BRITISH GLIDING ASSOCIATION

BGA TECHNICAL COMMITTEE

TECHNICAL NEWSHEET    TNS 9/10/91

PART 1    Airworthiness "AGGRO" - Please add to the BGA 1991 Blue Pages.

OLYMPIA 2B  
ELEVATORS / ALERONS  
CRACKS

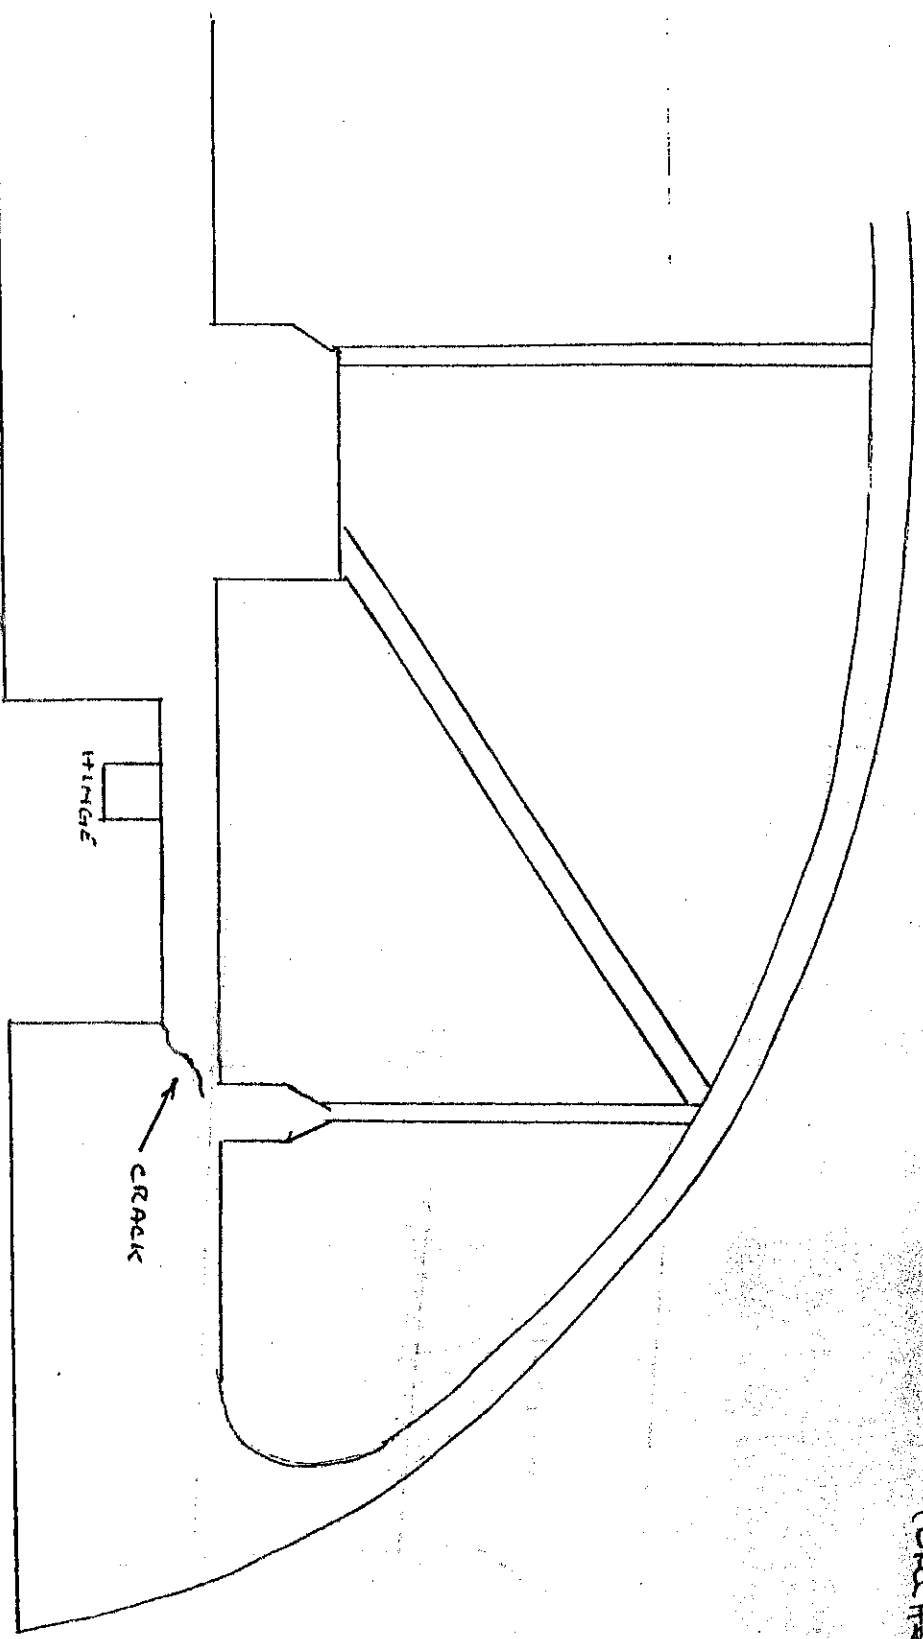
- 1.7.    Slingsby Dart.    Defective Panel in the wing root - Sketch from Ian Hipkin - Highlands G.C. is self explanatory.
- 1.8.    OLY 2 - Cracks in Elevators & Ailerons.    Sketch from Ian Hipkin may have been omitted from TNS 7/8/91.

# T.21 AILERON ROD FAILURE.

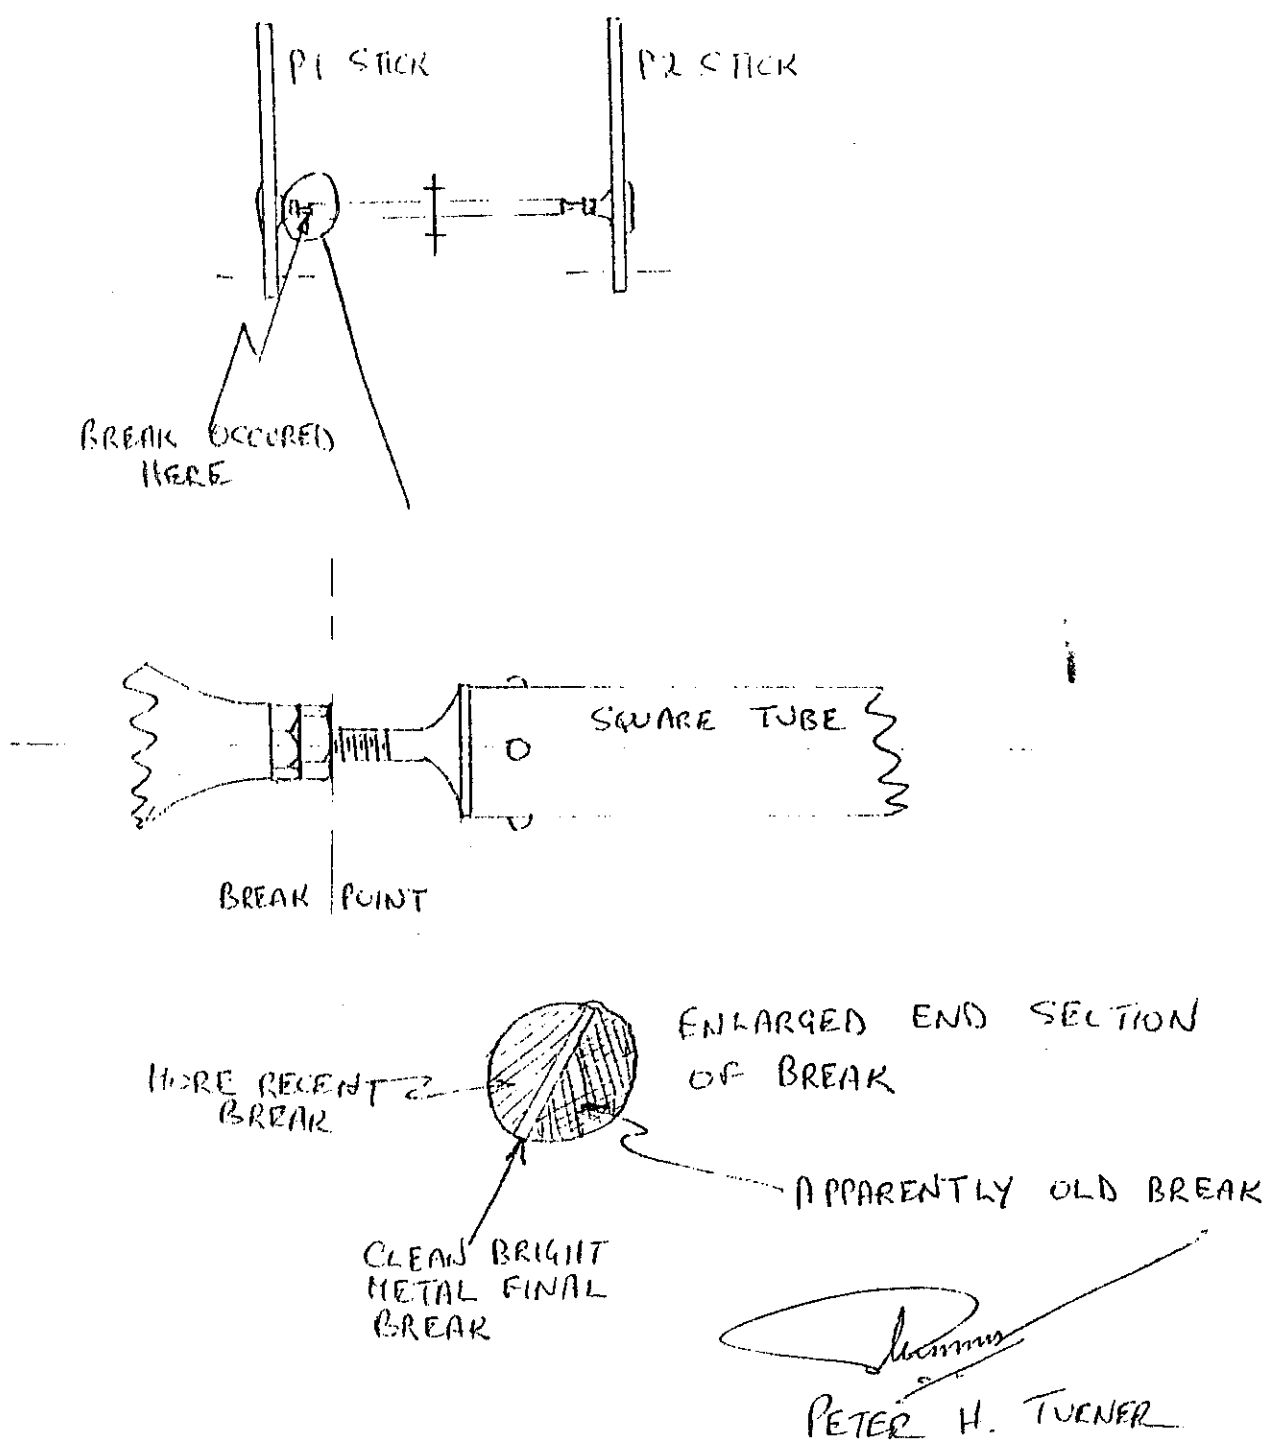
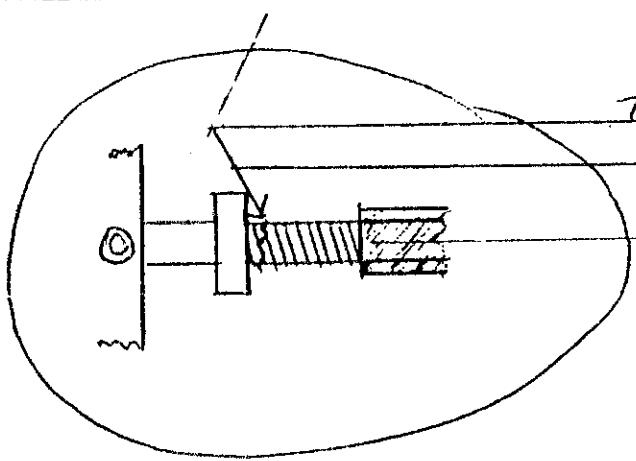
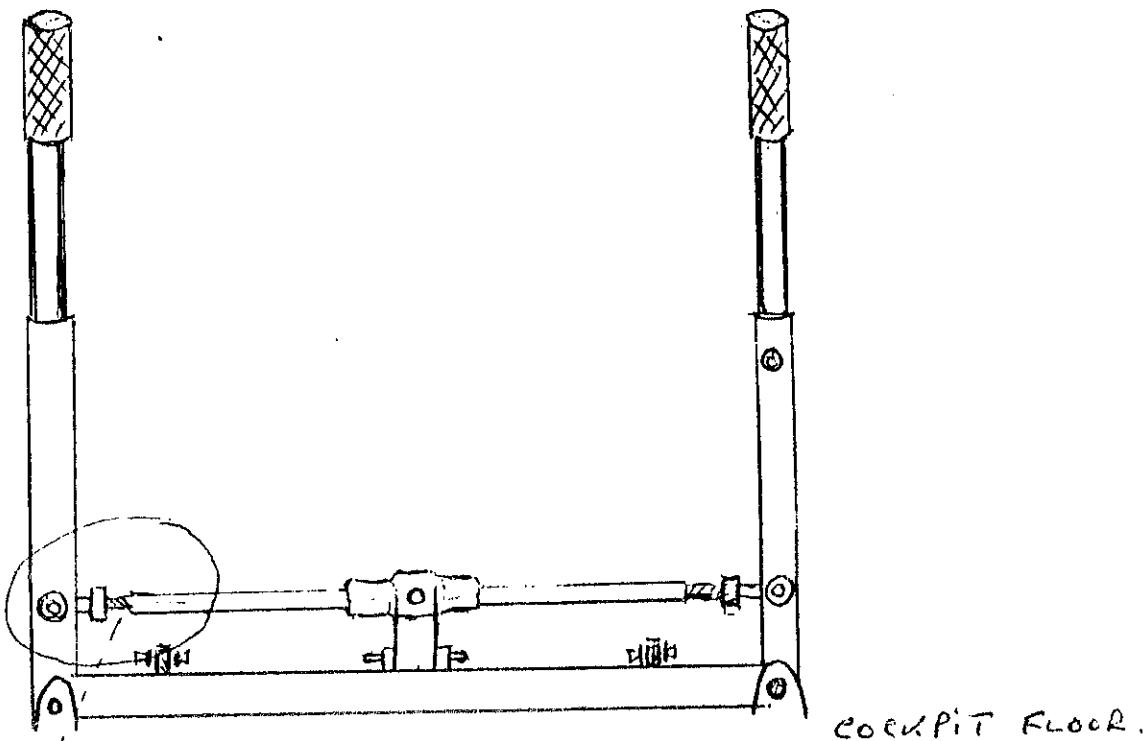
- 1.4.    T.21. Undemanded Aileron Disconnect - due to fracture of the rod-end between the two control sticks. First reported in TNS 6/83. Sketch herewith illustrates the failure, probably induced by treading on it? Why not paint it bright RED?

I will, shortly, complete and return the Incident Report and will send the broken parts to yourselves for inspection if required. From visual in situ inspection there appears to be two separate previous cracks with the final break only about 1 mm wide. The crack has occurred at the maximum stress point where a thick section is suddenly reduced to a thin section and this thin section is also threaded at this point.

T216. DUKER CONTROL STICK.  
PORT SIDE CONTROL ROD.  
BROKE OFF - IN FLIGHT.

THREADED PART OF  
CONTROL ROD BROKE HERE.

Datum		Rolladen-Schneider Flugzeugbau GmbH		Maßstab: 1:1	
Ben		Benennung		Zeichn.-Nr.	
23.8.91		Hauptauschnitt Anlage cutout		41-86	
Gopr		IM/IB 7004			
23.8.91					
Oberflächenschicht:			Kontrollvor:		BZ-Nr.
Rißprüfung:			LS7		BZ-Nr.
Pos.	Stück	Benennung		DIN/LN	Werkstoff
					Zeichn.-Nr.

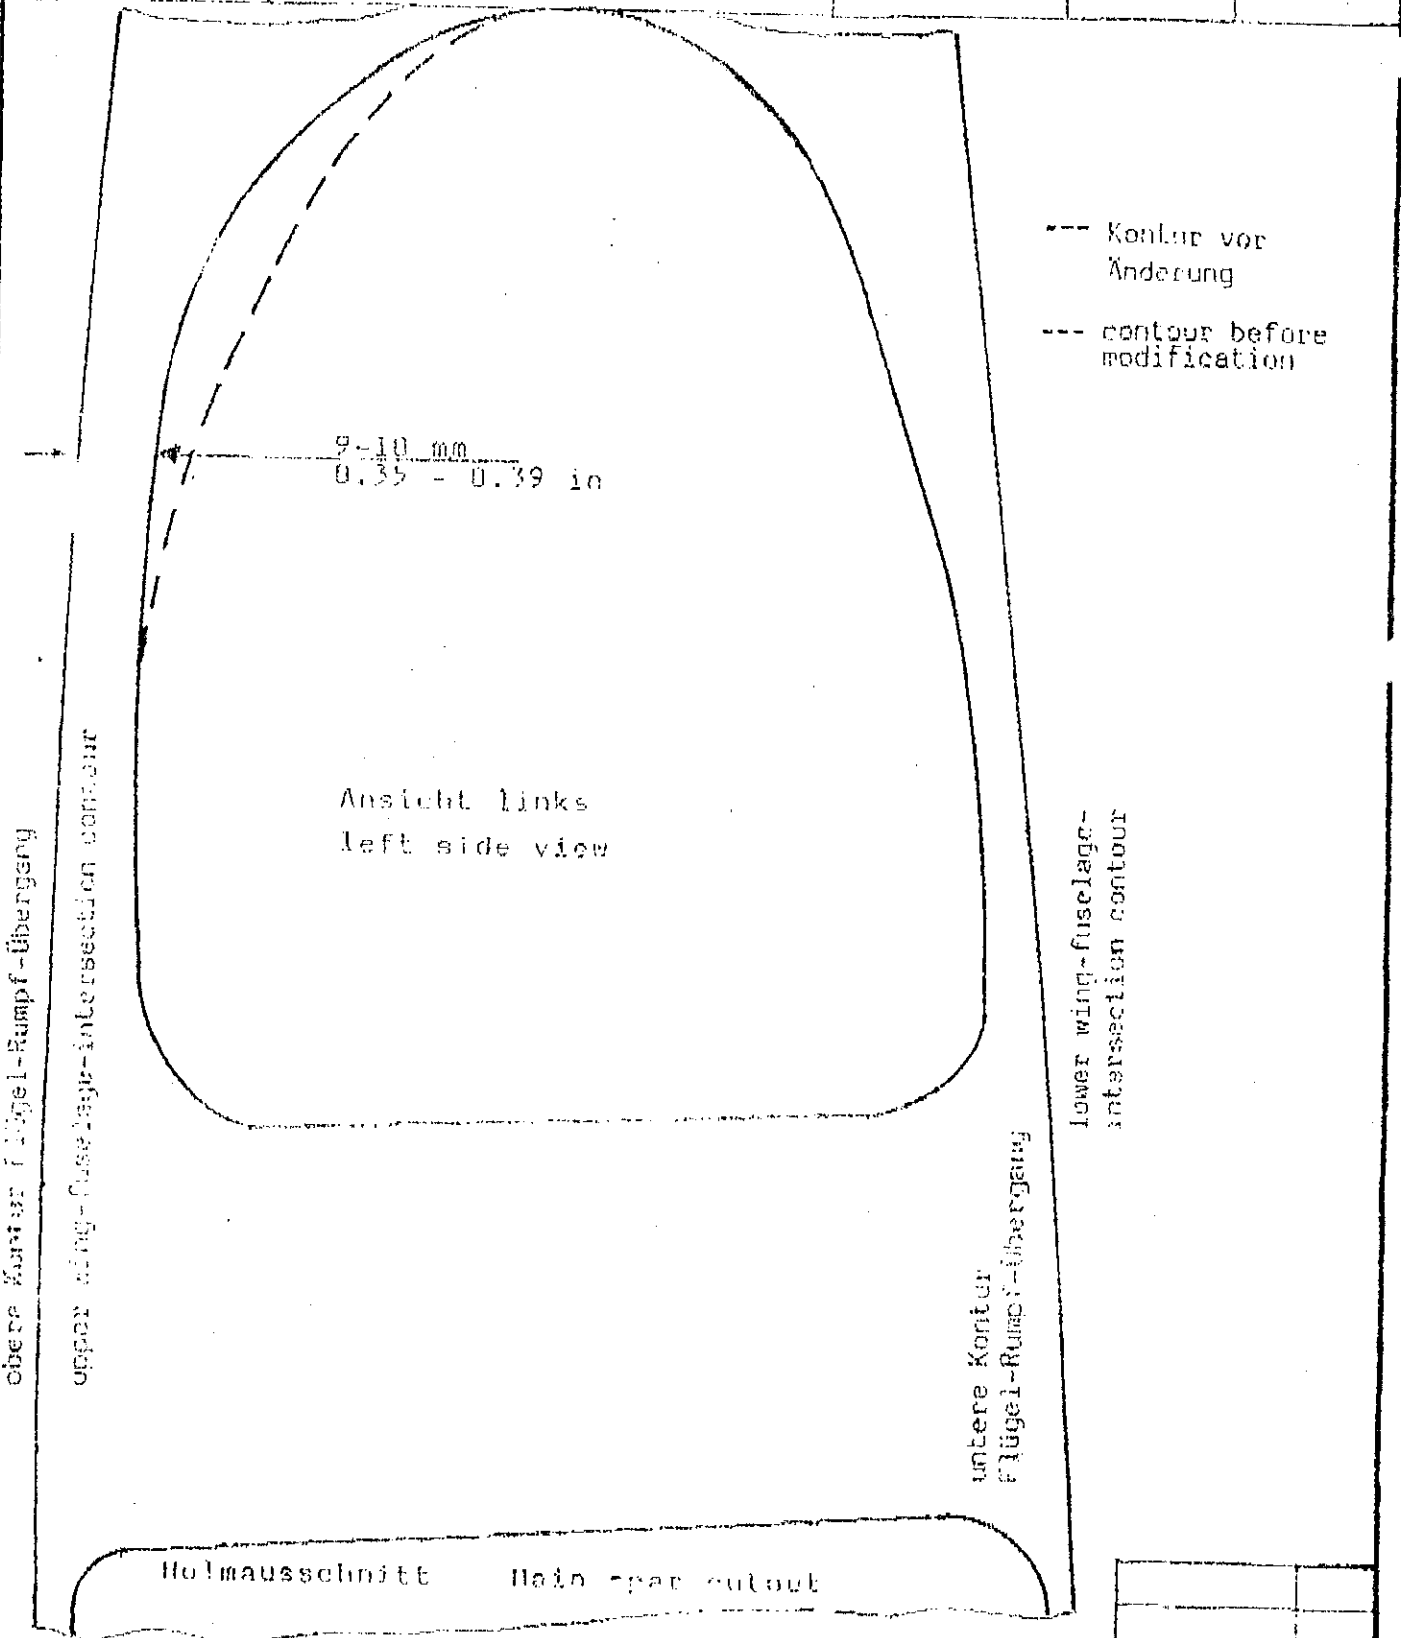
: In one case the deflector was bent to the rear during careless rigging of the wings, that the aileron movement was blocked.

- : 1.) Check deflector for straightness. If bent, parts must be exchanged.
- : 2.) Enlarge fuselage cutout in connector region to upper rear according to included drawing 4I-86 to prevent jamming in case of inadvertently bent deflectors.

## E1. CORRODED EXHAUST VALVE

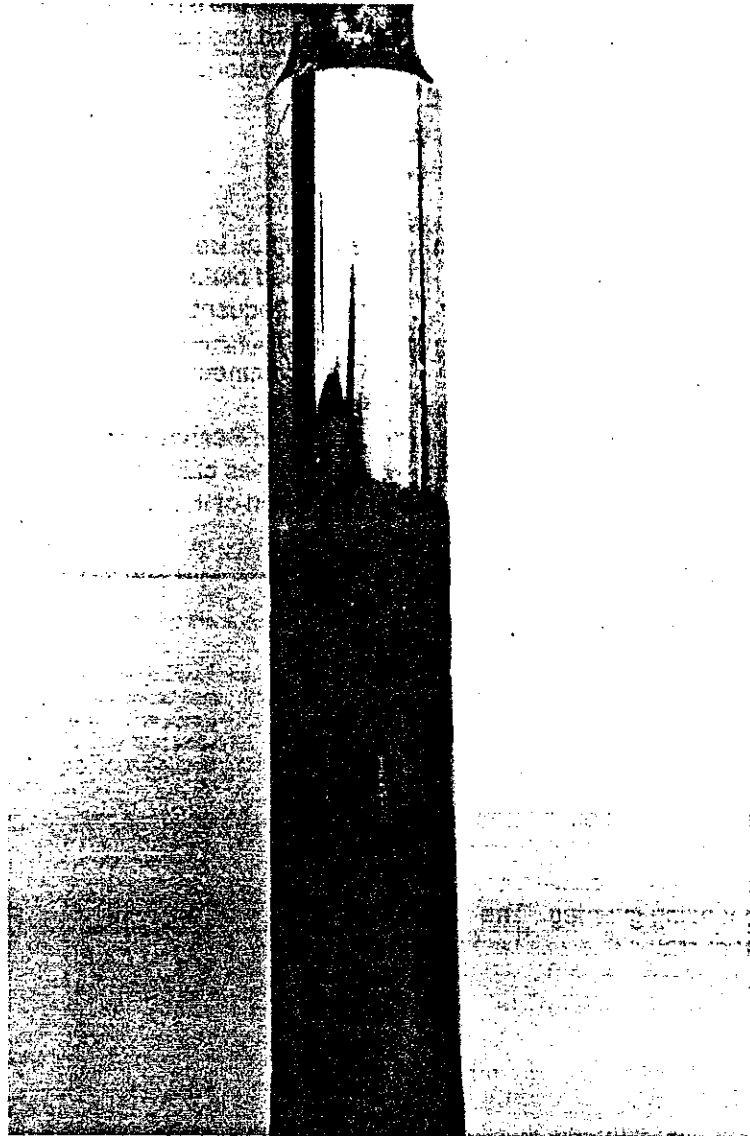
The aircraft had been out of use for some time and the engineer decided to remove one of the cylinders from the engine for inspection. Closer inspection revealed wear in one of the valves and upon removing the exhaust valve found the stem of the valve to be badly corroded in several places. The photograph illustrates this.

He then checked all of the exhaust valves and most of them were in a similar condition.

The engineer makes the comment that this situation could well occur on other aircraft which have limited utilisation or long periods when they are not flown.

Lycoming Service Letter L180A, dated 1 December 1978, details the measures to be taken to minimise such problems.
